PIC18F85J11 Family Data Sheet Errata

Clarifications/Corrections to the Data Sheet:

In the Device Data Sheet (DS39774C), the following clarifications and corrections should be noted. Any silicon issues related to the PIC18F85J11 family will be reported in a separate silicon errata. Please check the Microchip web site for any existing issues.

FIGURE 16-10: I²C™ SLAVE MODE TIMING (TRANSMISSION, 7-BIT ADDRESS)

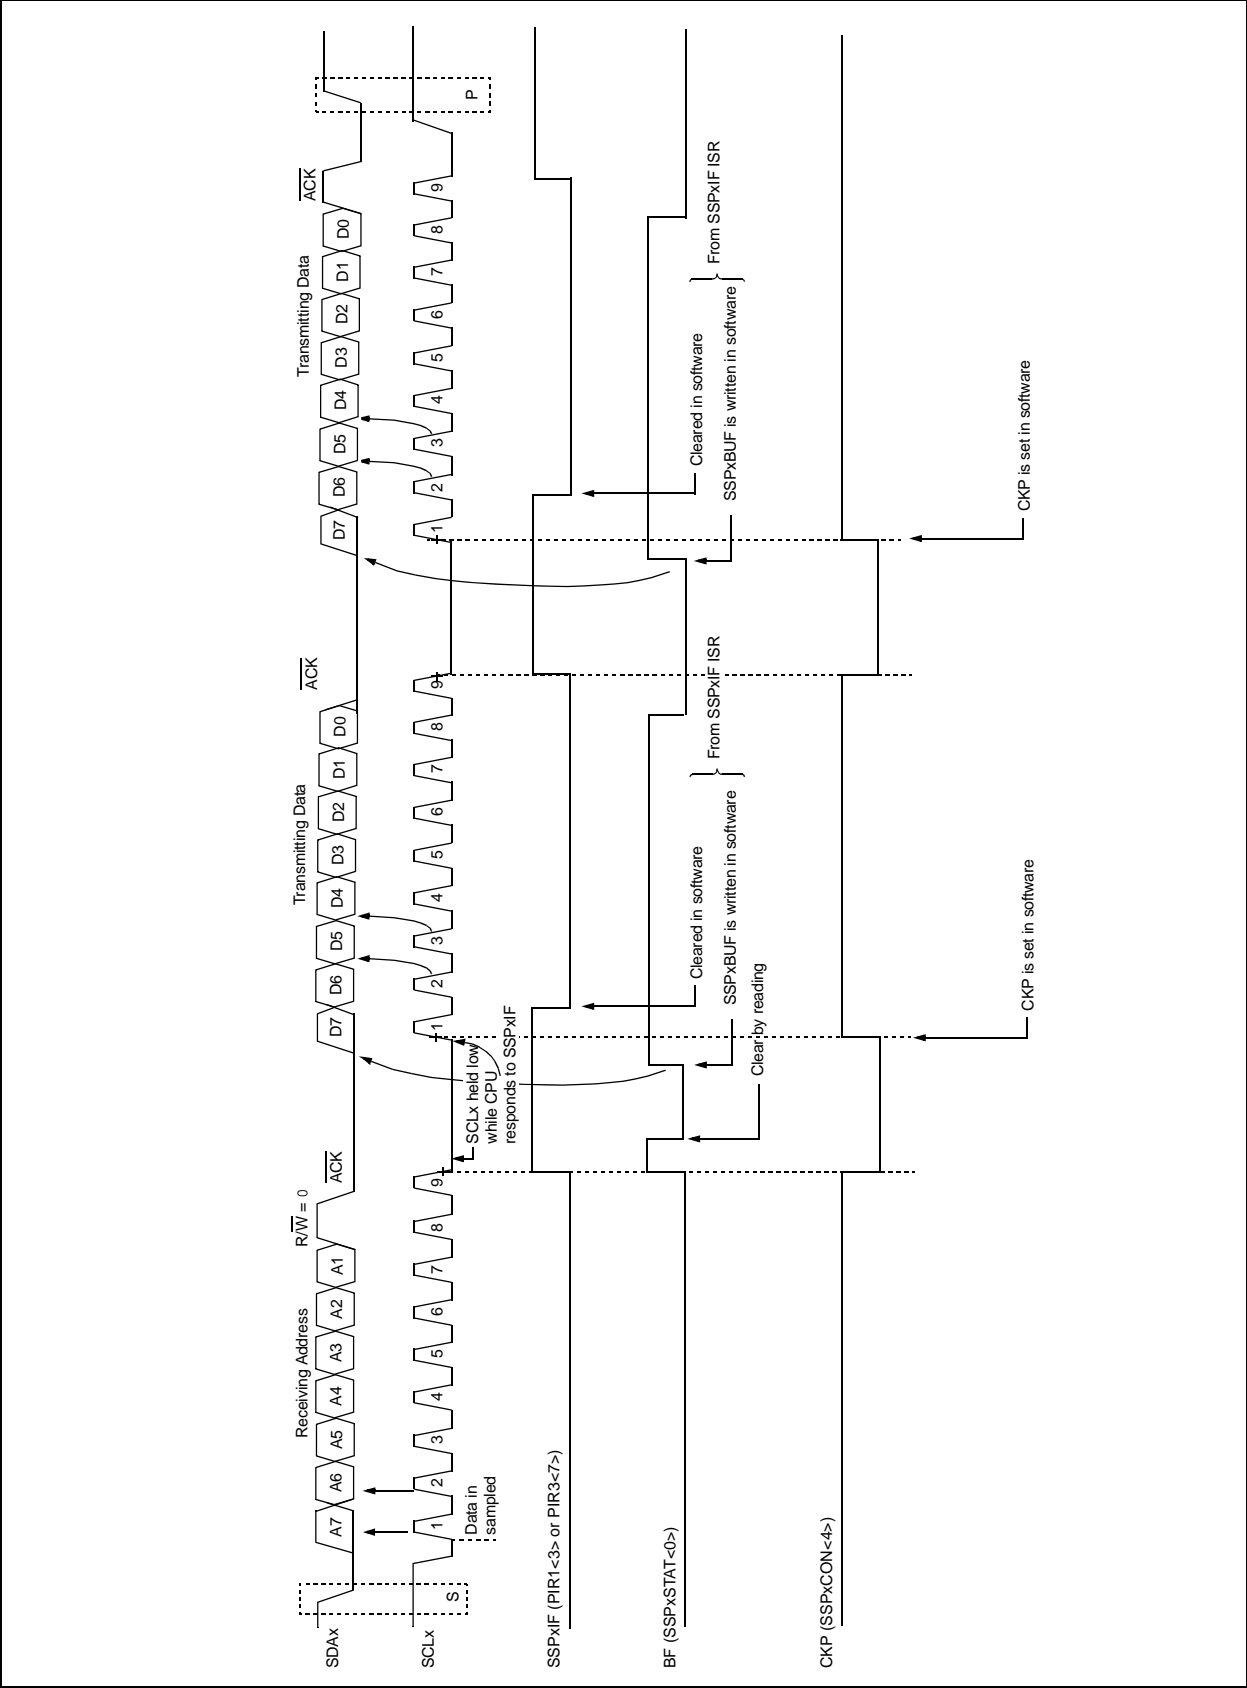
11. Module: Figure 16-10: I²C™ Slave Mode Timing (Transmission, 7-Bit Address)

On page 192, the figure is replaced with the new timing diagram provided in Figure 16-10.

FIGURE 16-24: I²C™ MASTER MODE WAVEFORM (RECEPTION, 7-BIT ADDRESS)

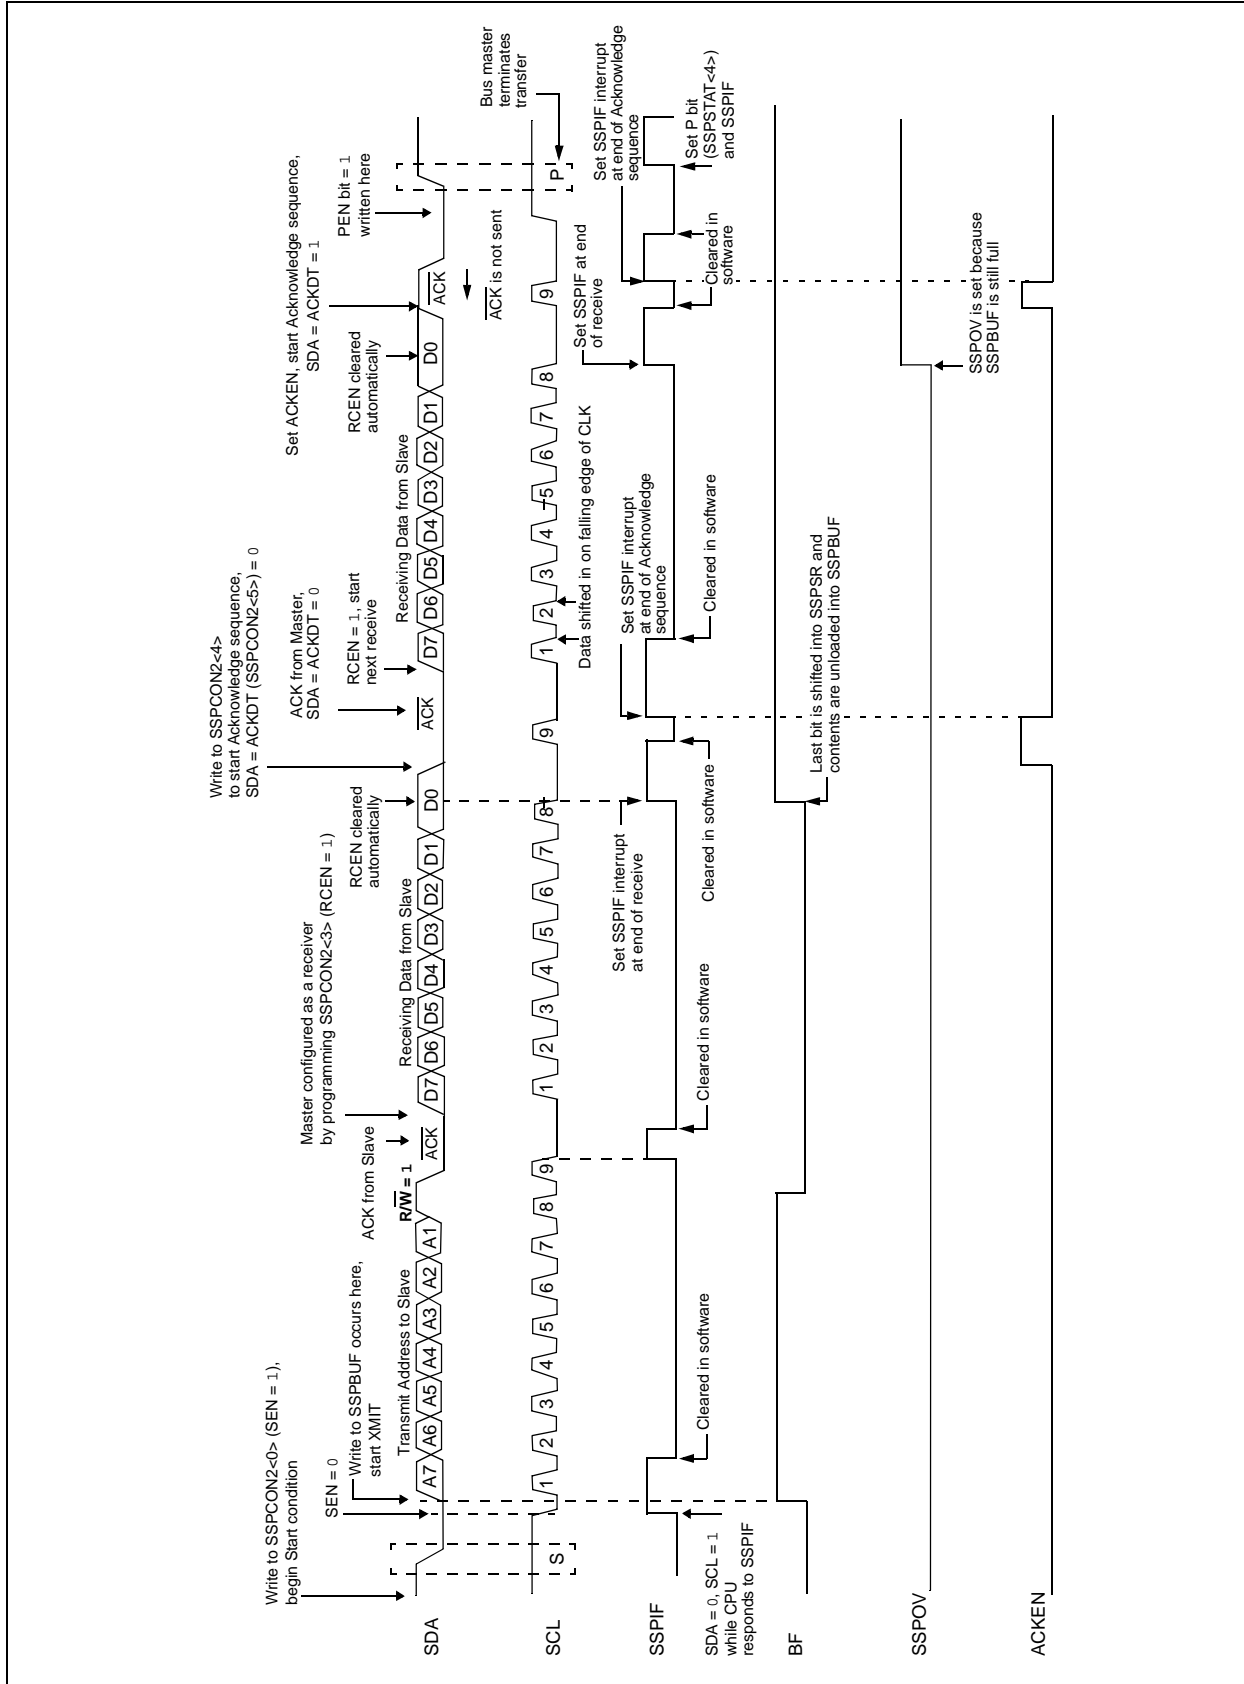
12. Module: Figure 16-24: I²C™ Master Mode Waveform (Reception, 7-Bit Address)

On page 209, the condition ($\overline{R/W}$) when the Acknowledge signal (ACK) is received from the slave, after transmitting the address to the slave, is changed to '1'. The changed value is indicated in bold text in Figure 16-24.

FIGURE 9-1: GENERIC I/O PORT OPERATION

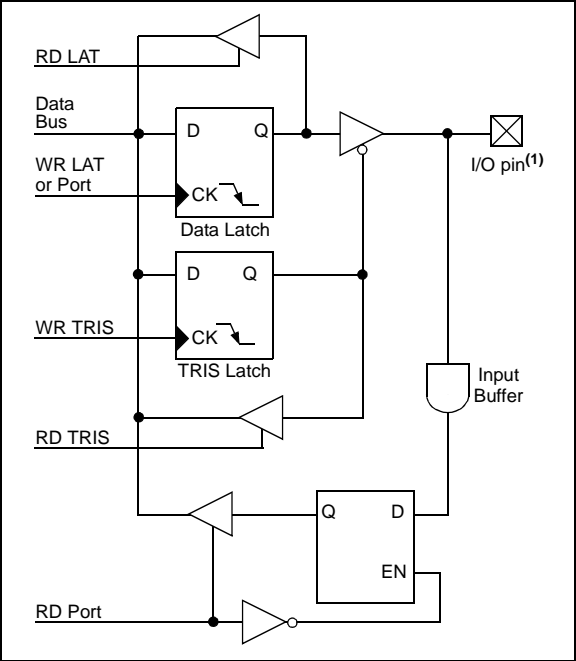
14. Module: Figure 9-1: Generic I/O Port Operation

The note in Figure 9-1 on page 123 is removed.
